*Revised 10GBASE-T PHY Control with
integrated link monitor (version2)*
Slide version of submitted Word document

**IEEE P802.3an Task Force
Milpitas, October 17-18, 2005**

Gottfried Ungerboeck

Figure 55-bb—PHY Control state diagram ... (upper part)

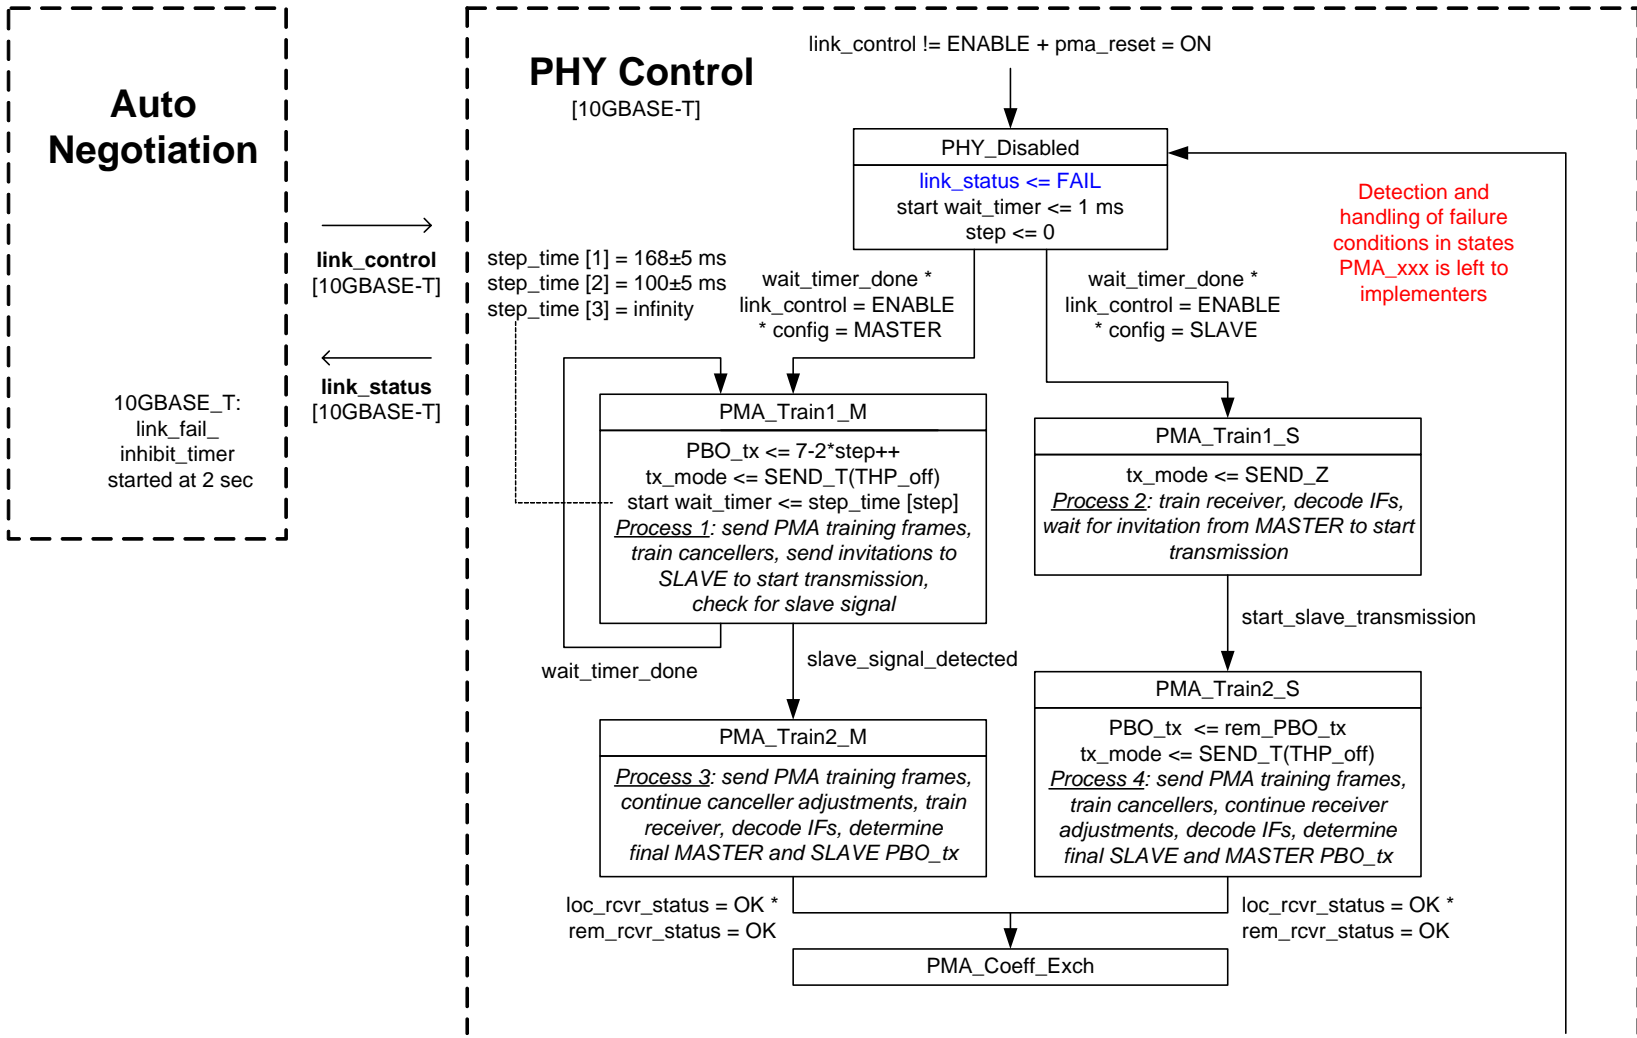
- **Auto Negotiation, PHY Control, and Link Monitor**
 - Link monitor function is part of PHY Control
 - Redundant maxwait_timer is eliminated; small change in Auto Negotiation state diagram permits restarting link_fail_inhibit_timer in case of PMA retraining.
- **InfoFields (IFs) reorganized and shortened to 8-octets**
 - 3-octet start-of-IF-delimiter + 4-octet payload + 1-octet CRC-8
 - Number of unused bits and redundant use of bits significantly reduced
 - 2-bit state indicator shows PHY Control state of transmitting PHY.

Figure 28–16—Arbitration state diagram

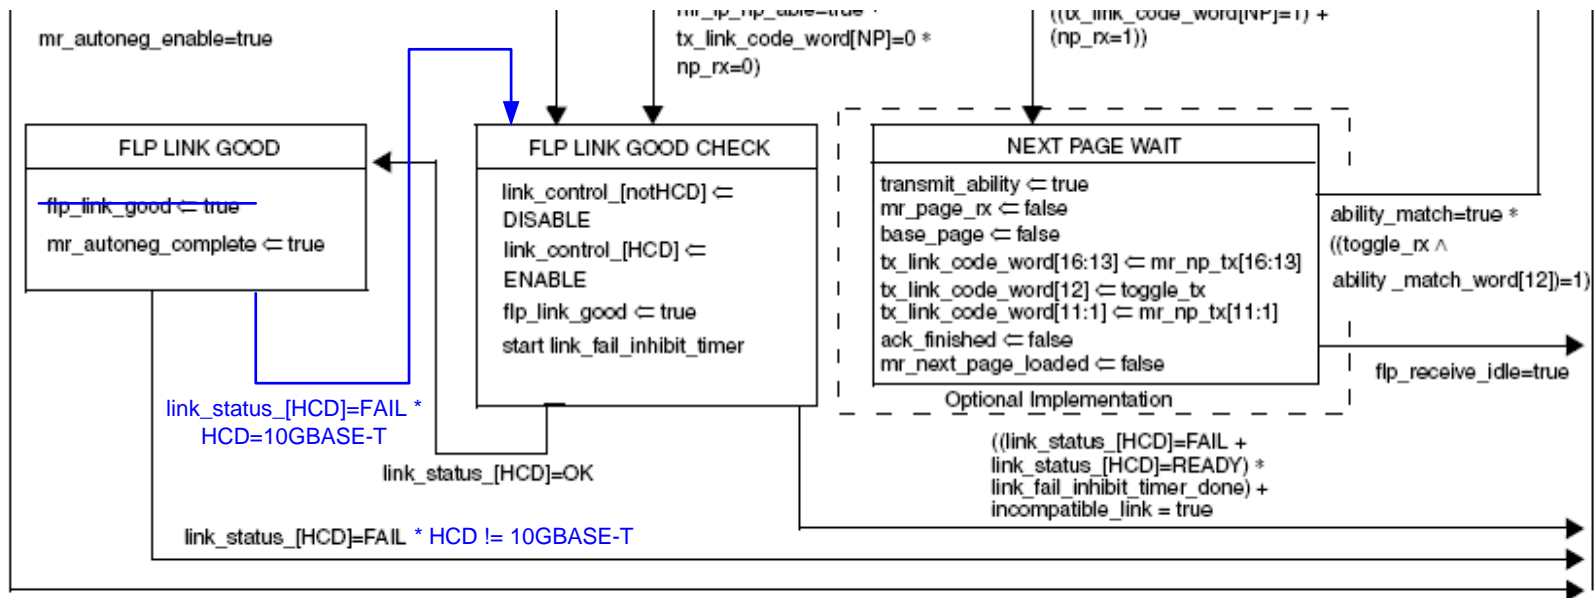
Change required in Auto Negotiation
